# 320 TODD ROAD DEVELOPMENT

## CIVIL CONSTRUCTION PERMIT

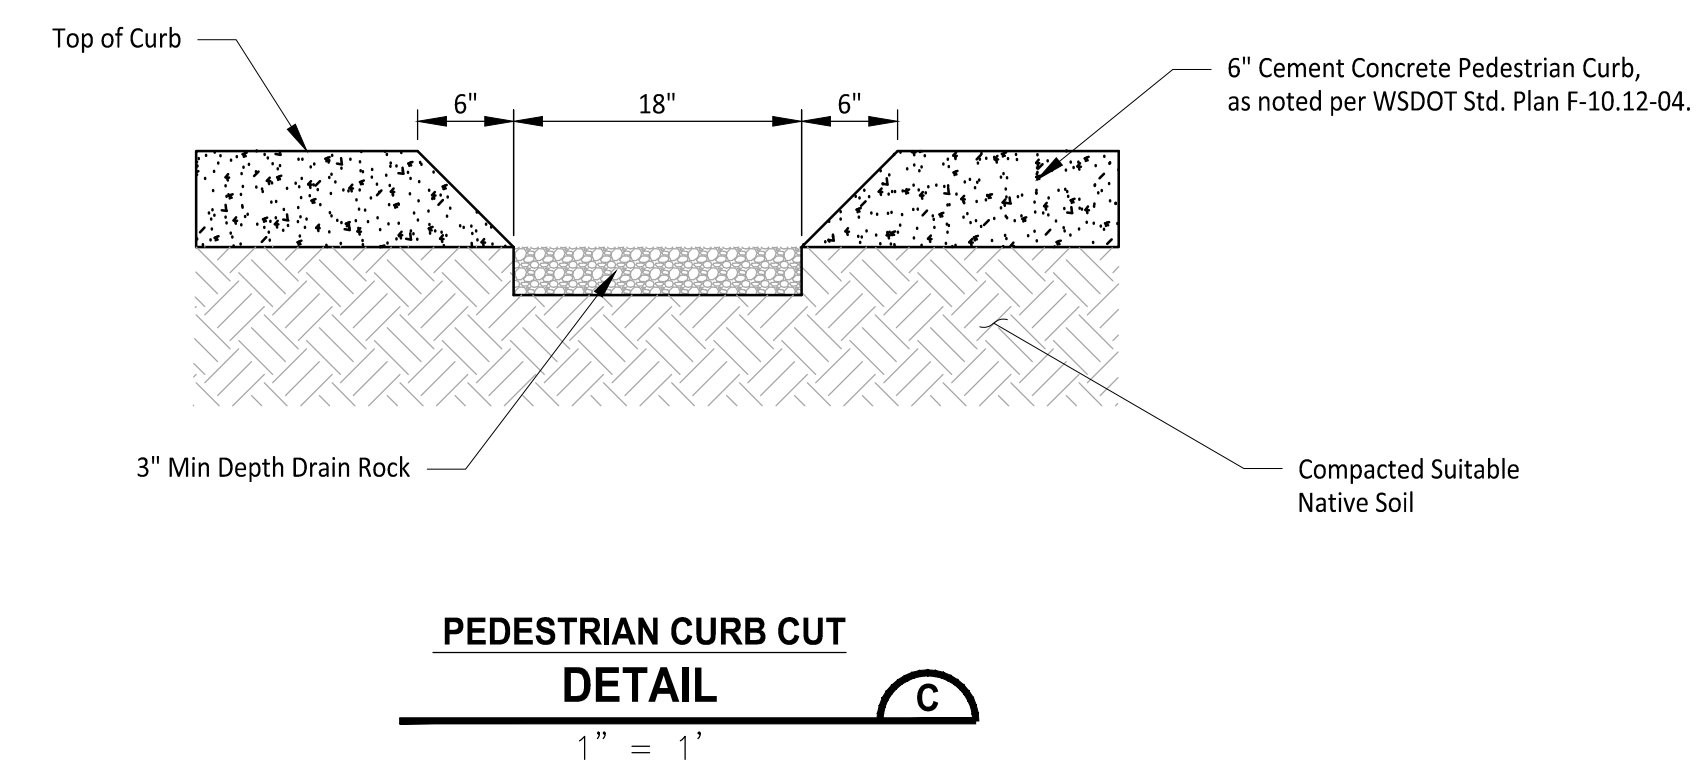
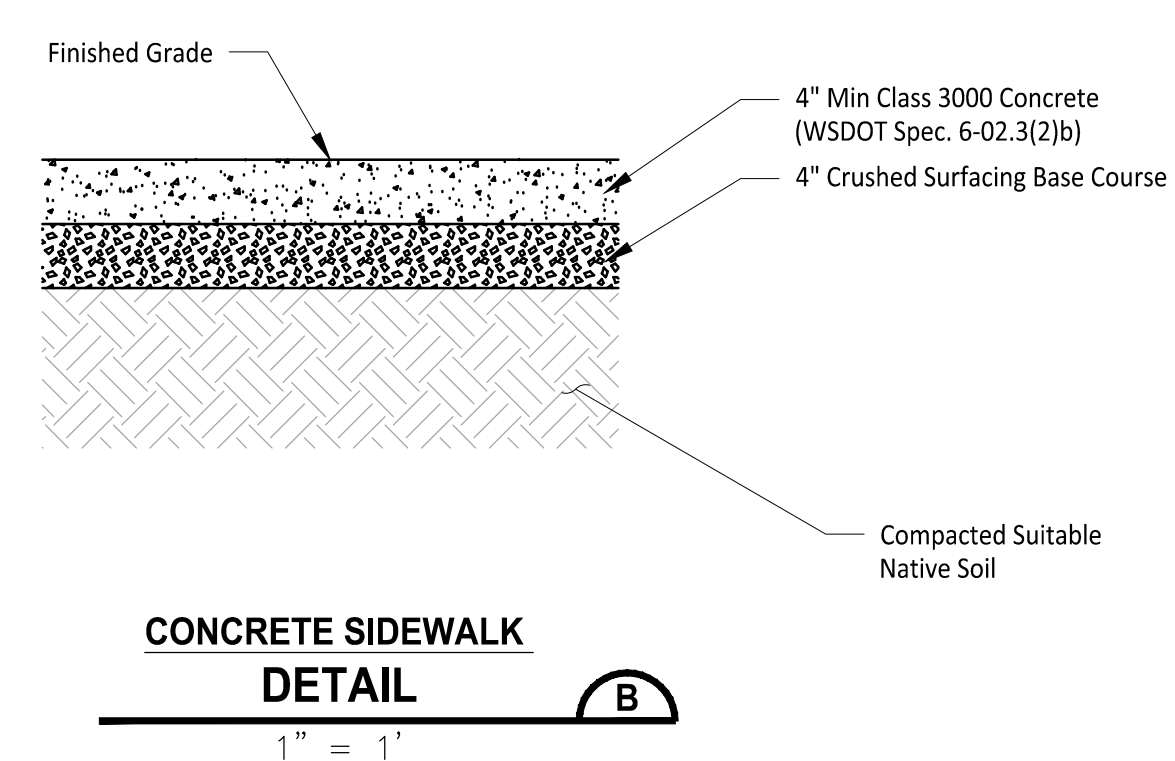
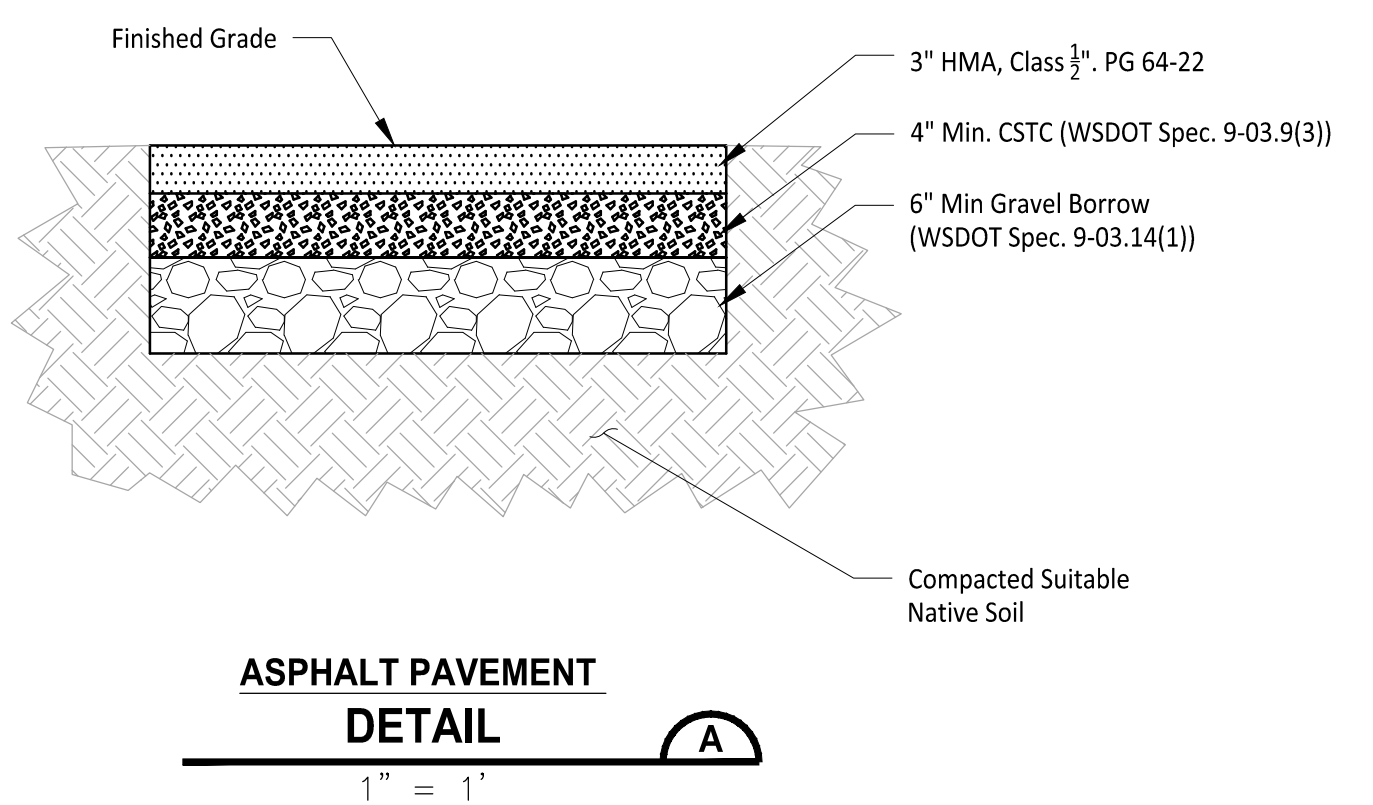
Include and adhere to Detail 01.01.20 for utility trench restoration for the storm connection.

Type III Barricade for future extended sidewalks required. Include and adhere to Detail 01.02.20.

## Composite Utility Plan

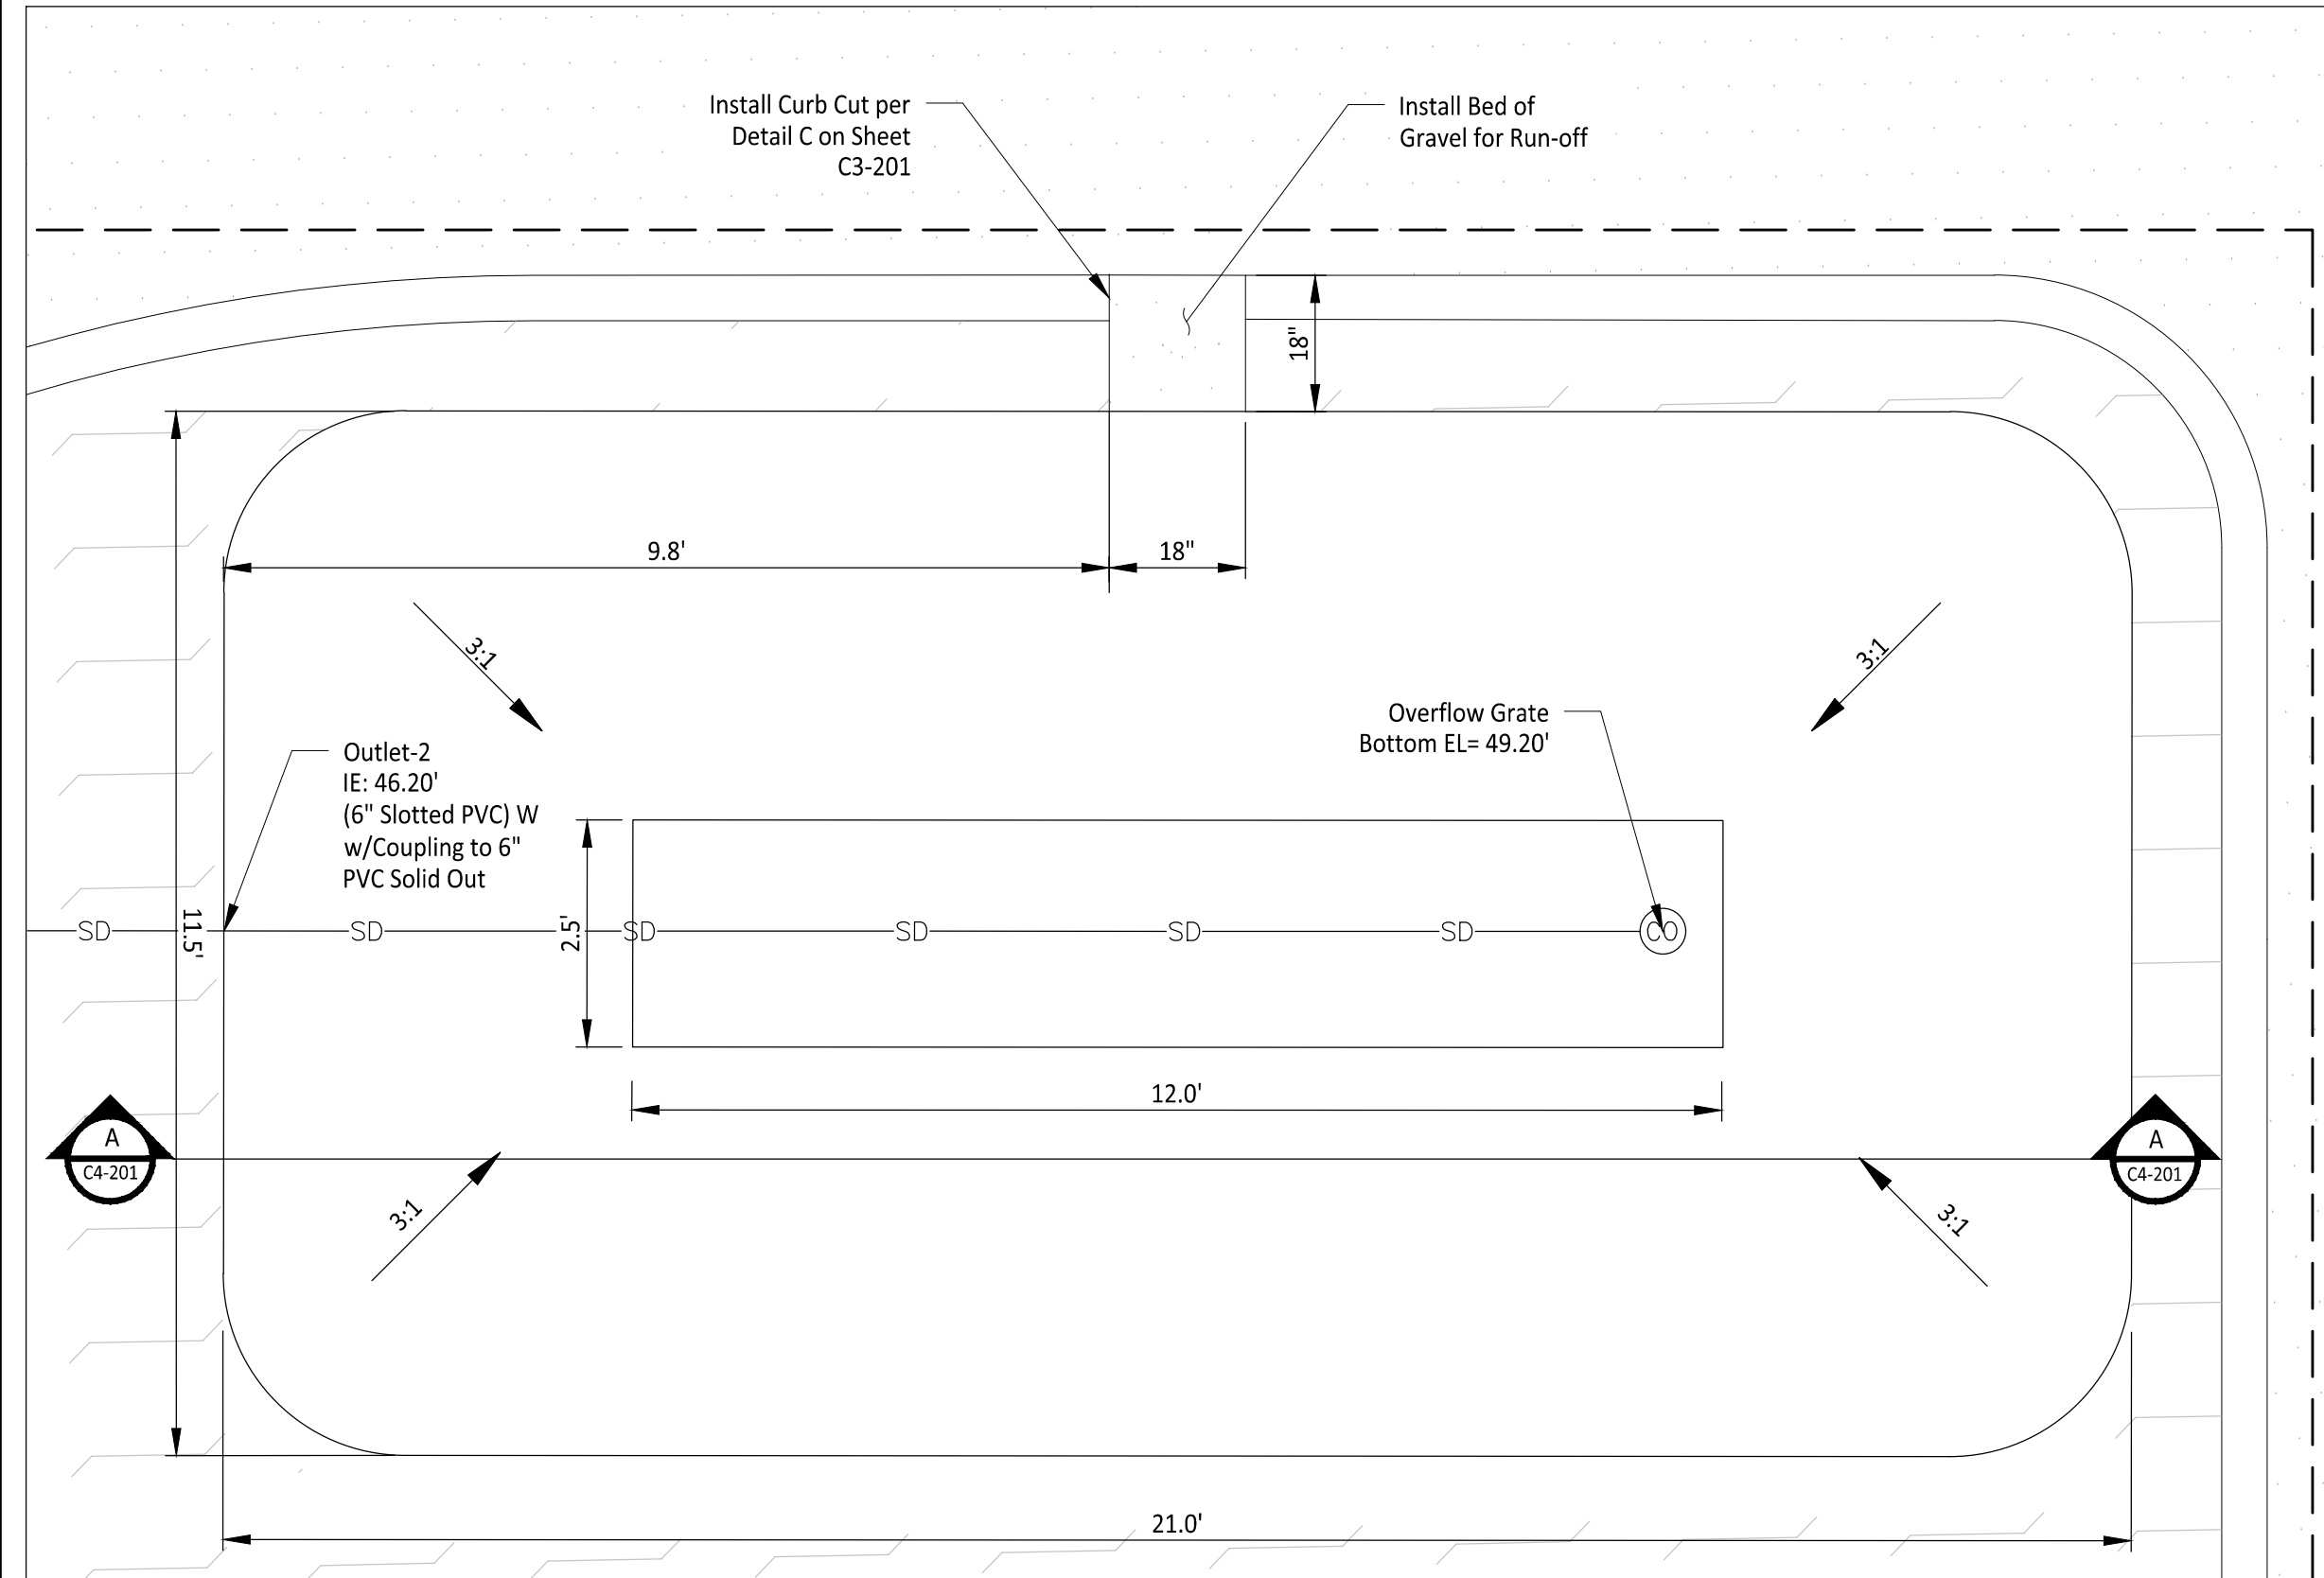
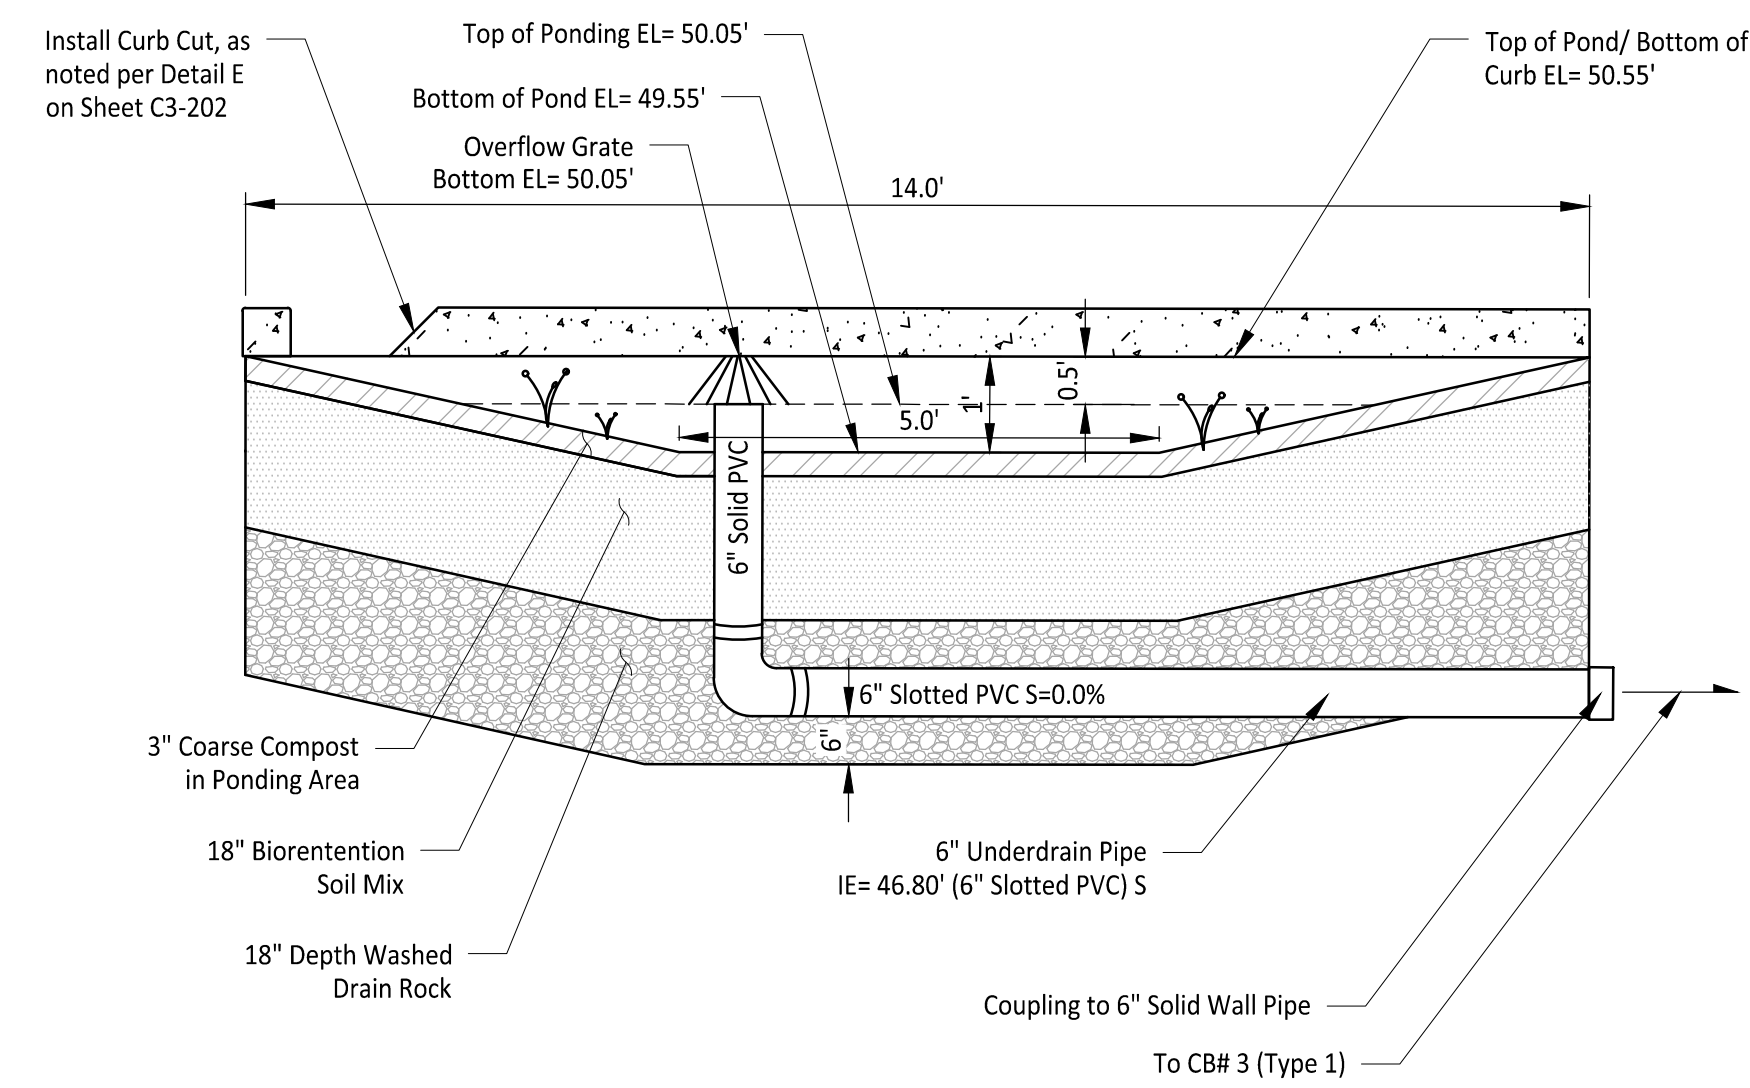
Provide details for planting of bio-retention swales. The city has Standard Details for Bioretention Cells/Swales. Include Detail 02.07.05 for planting and either use the City Standard Details 02.07.01 and 02.07.03 instead of custom details or ensure that the custom details on C4-201 conform with City Standard Details 02.07.01 and 02.07.03 for thicknesses and type of material. Curb cut for drainage is OK. Include any pertinent notes from standard details on custom details if used (ex.: Detail 02.07.01 requires 3 inches of scarification to the sub grade. This note does not appear in the custom details).
